PERCOLATION TESTING

HOWARD COUNTY HEALTH DEPARTMENT  
BUREAU OF ENVIRONMENTAL HEALTH  
3525-H ELLICOTT MILLS DRIVE/ELLICOTT CITY, MARYLAND 21043  
TELEPHONE: 313-2840

Kooshah Garden Review 8/17/99 continued from 8/10/99

**KOANDOAH GARDENS**  
**Phase I**  
**Septic Disposal Areas (SDA)**

A57612  
COUNTY #

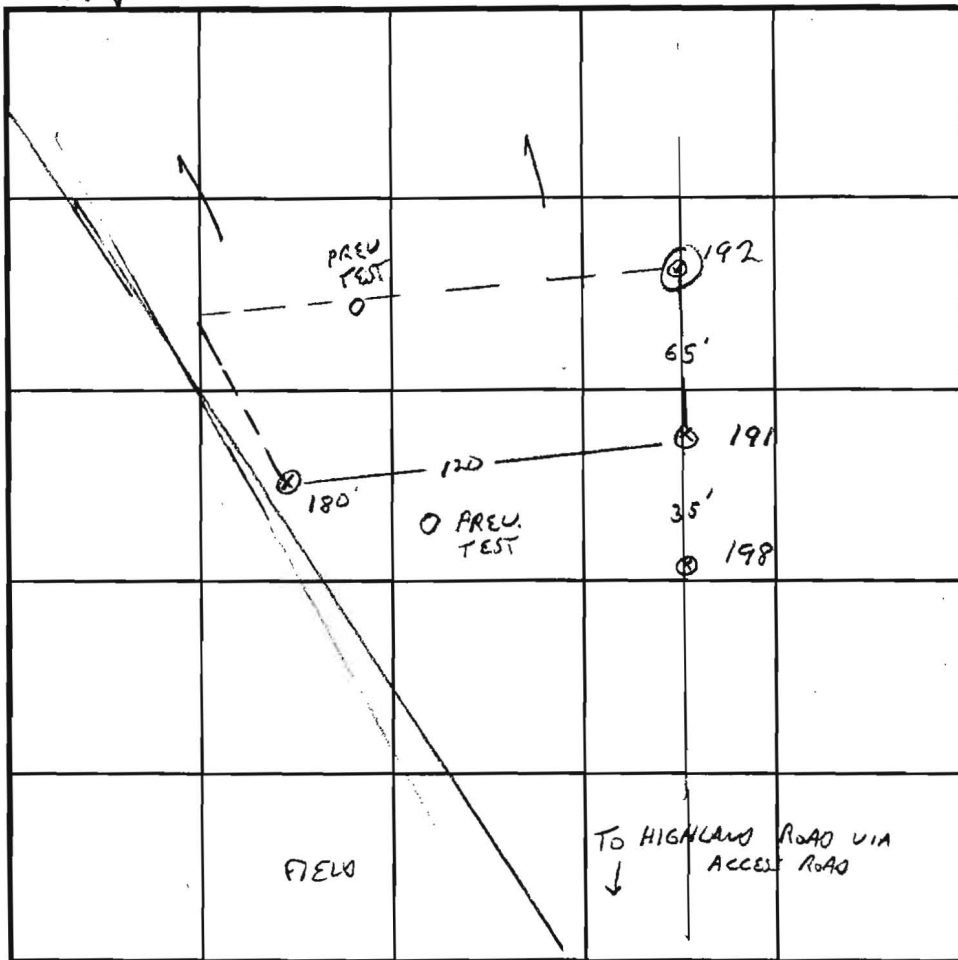
REMARKS LOT 19, SEE ALSO LOT 20, 18 WATER TABLE CONCERN, LOWER EDGE

A57612

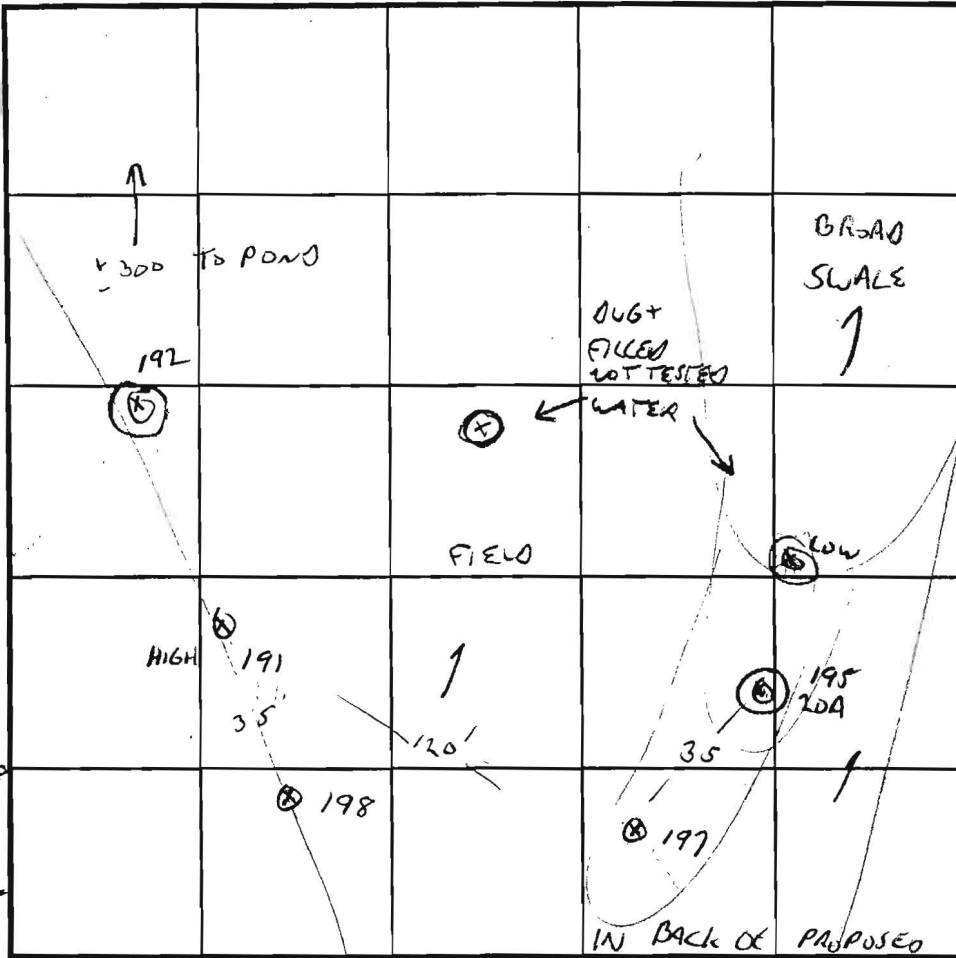
REMARKS LOT 20 WATER TABLE CONCERN

F02-07 All perc test holes  
Signed excavated not shown

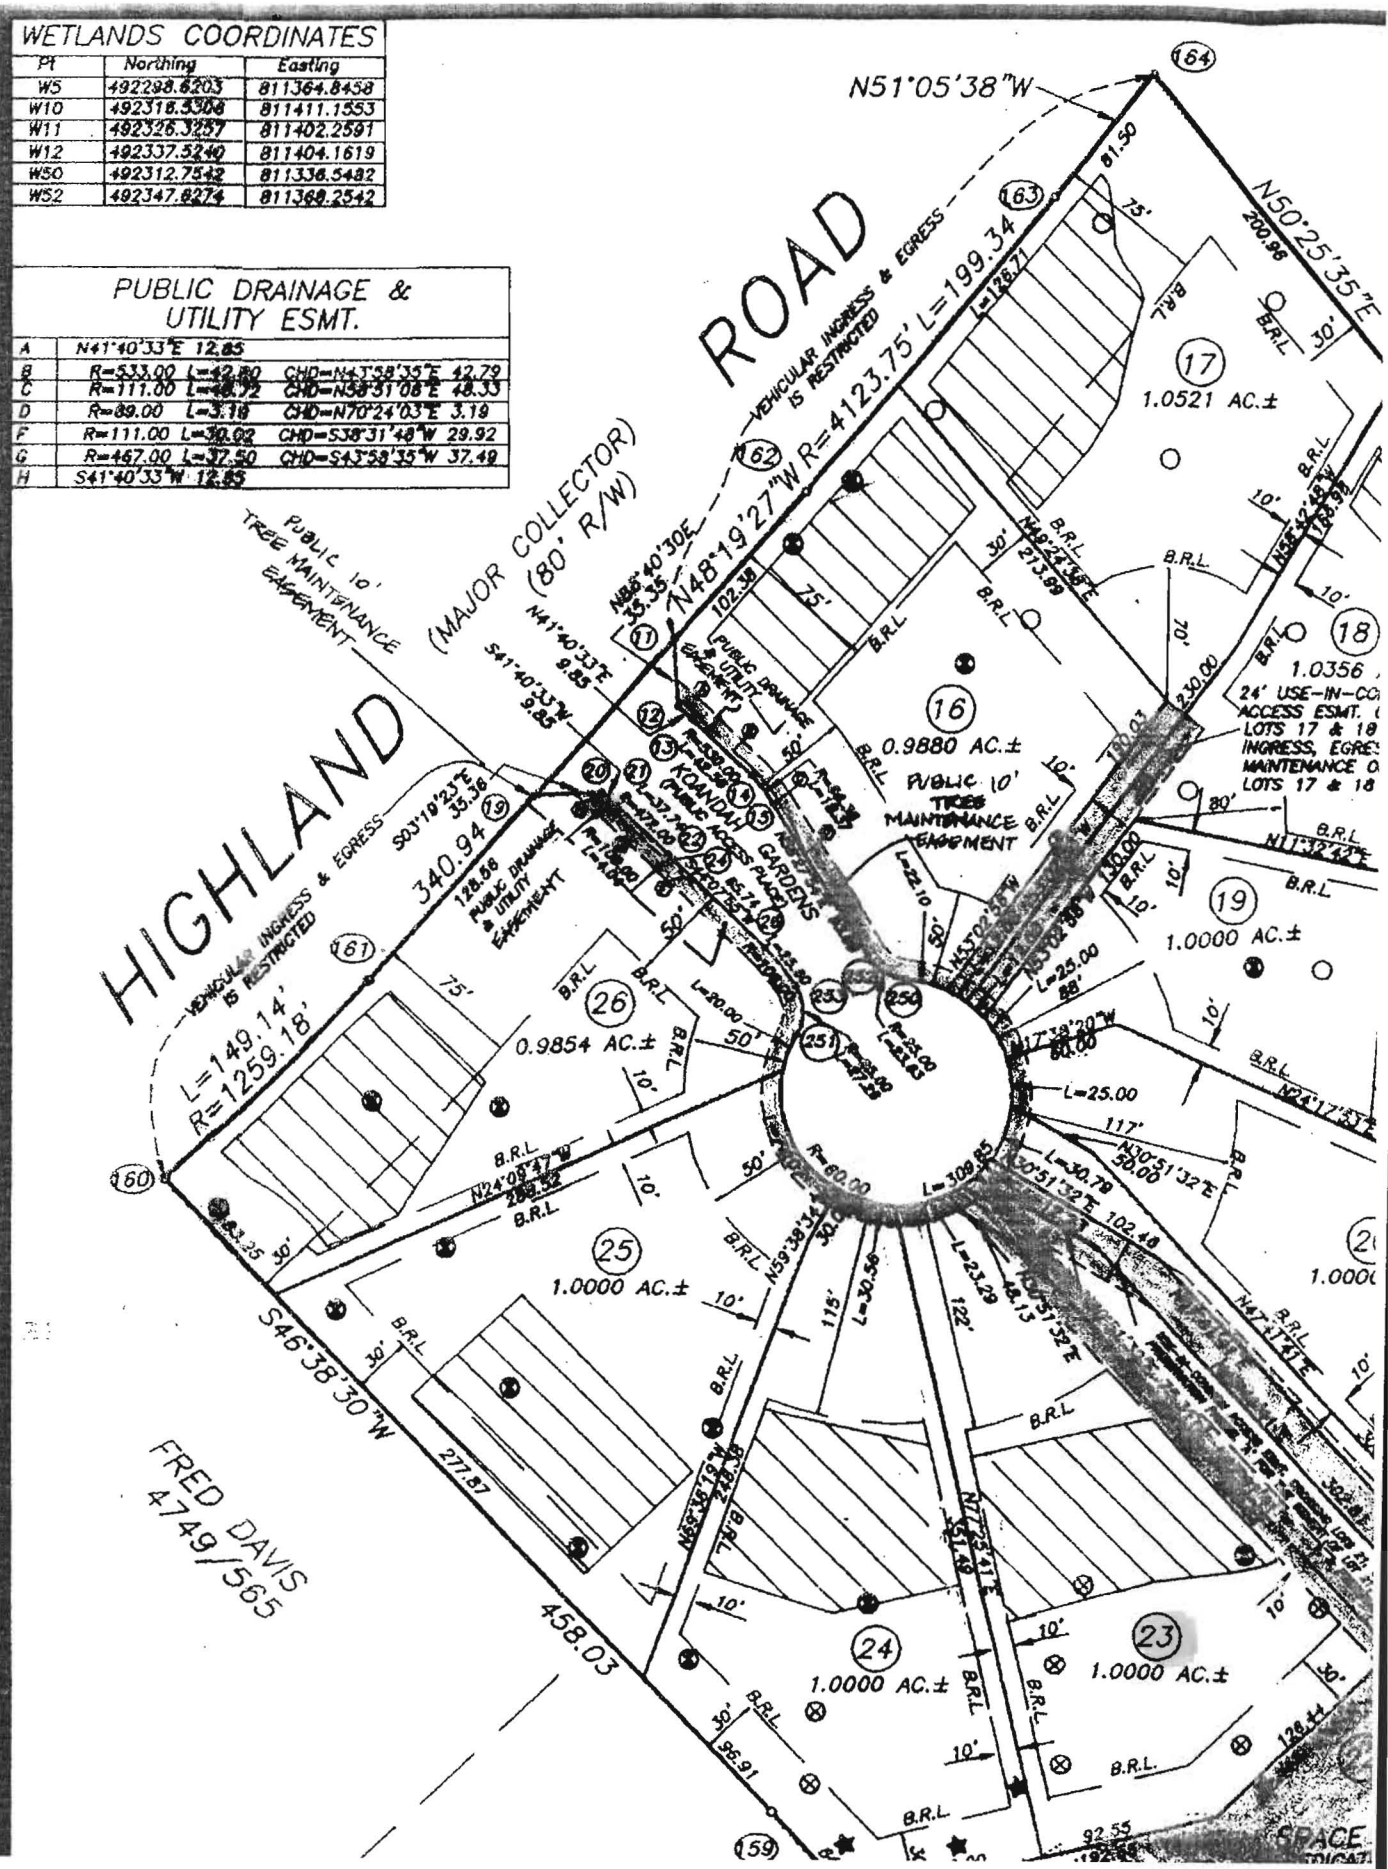
LOT 23

JAN 97 WATER @ 10' (MOTTLES 4-6 - DISCOUNTED BY THE JAN 97 READING)  
ABSOLUTE HIGH

195 PORED AT 4'

197 DIDNT PORE AT ALL

TO USE THE CONTOUR OF HOLE 196

LOT 22

ALL HOLES FAIL
